Service Bulletin

LAUNDRY
ALL "HYDROWAVE" MODELS

HL 01-07

MOTOR-INVERTER DRIVE SYSTEM – 2 FLASH INVERTER BOARD ERROR (MOTOR APPEARS DEAD)

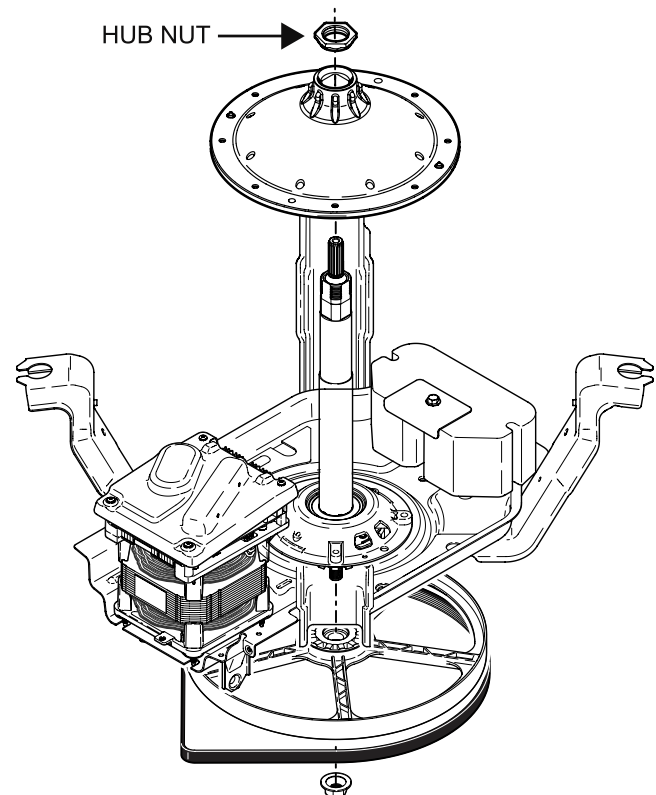
The **2 flash error** was intended to represent a slipping belt condition as identified in the mini-manual. Based on field feedback, a **loose hub nut** may also simulate the conditions that the inverter uses to detect a slipping belt condition. Because a slipping belt presents a safety concern for the machine to brake/stop normally, the inverter disables the motor while setting the **2 flash error** code. The motor will not agitate or spin in this condition, so the **motor appears DEAD**.

A **loose hub nut** may be obvious in severe circumstances where the basket has damaged the balance ring, the tub cover, or the tub. In some instances, it is more difficult to detect if the hub nut has not fully backed off. NOTE: The HYDROWAVE drive does not have a mechanical brake like the drive system with transmission. The basket may rotate freely depending on the state of the mode shifter assembly. It may require closer inspection of the hub nut. If the threads of the nut are damaged, the nut will not hold the tub securely. Always **replace the hub nut if any damage** is noticed. Tighten the nut to **110 ft. lbs**.

Procedure for repair:

1. Remove the agitator and agitator coupling
2. Inspect for damaged components (replace as necessary)
3. Tighten the hub nut with a torque wrench or impact gun (current factory torque setting is 110 FT-LBS)

Clearing Motor-Inverter error codes:

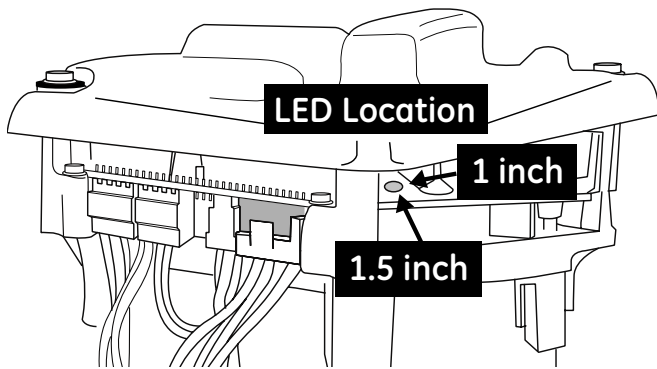
The LED is best viewed from the right front of the motor, 1.5" back and 1" into board.

1. Disconnect the washer from power and wait approximately 15 seconds (hear a click/capacitor discharge)
2. Reconnect the washer to power and allow the relay to click (approximately 2 seconds).
3. Open and close the lid 5 or more times (in any 12 second period within the first 30 seconds of power up)
